10/560,911

Office Action Summary	Application No. 10/560,911	Applicant(s) HAISER ET AL.	
	Examiner KEITH COLEMAN	Art Unit 3747

DETAILED ACTION

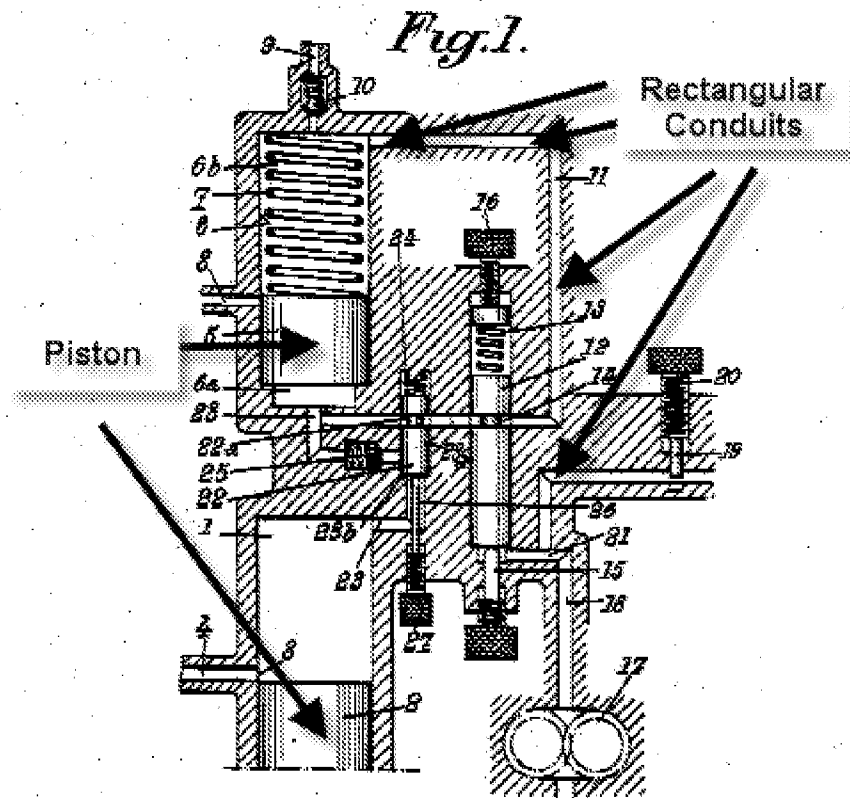
Applicant opines that a pressure amplifier is *not* a mechanical pump and further contends that Applicant's figures show a pressure amplifier and the claim language has been amended to recite piece by piece the claimed structure.

Furthermore, Applicant contends that Bessiere does not disclose an encompassing groove and does not teach a rectangular cross-section.

Using broadest reasonable interpretation, a pump is clearly defined as “an apparatus or machine for raising, driving, exhausting, or **compressing fluids** or gases by means of **a piston, plunger, or set of rotating vanes**” and Bessiere clearly discloses a pressure amplifier or mechanical pump.

As to Applicant's second argument, Bessiere clearly discloses Applicant's claimed structure and teaches the ostensible encompassing groove and rectangular conduits. Applicant is reminded to see MPEP 2125. Drawings and pictures can **anticipate claims if they clearly show the structure which is claimed.** In re Mraz, 455 F.2d 1069, 173 USPQ 25 (CCPA 1972). However, the picture must show all the claimed structural features and how they are put together. Jockmus v. Leviton, 28 F.2d 812 (2d Cir. 1928).

With regards the rectangular cross-section, Applicant has not defined a plane in which the conduits are traversed. Finally, the specificity found in Applicant's specification is not found in the claim language. Applicant is reminded to see MPEP 2111. In re Prater, 415 F.2d 1393, 1404-05, 162 USPQ 541, 550-51 (CCPA 1969) The court explained that "reading a claim in light of the specification, to thereby interpret limitations explicitly recited in the claim, is a quite different thing from 'reading limitations of the specification into a claim,' to thereby narrow the scope of the claim by implicitly adding disclosed limitations which have no express basis in the claim." Thus, the claim is not limited to such interpretation and the rejection still holds.
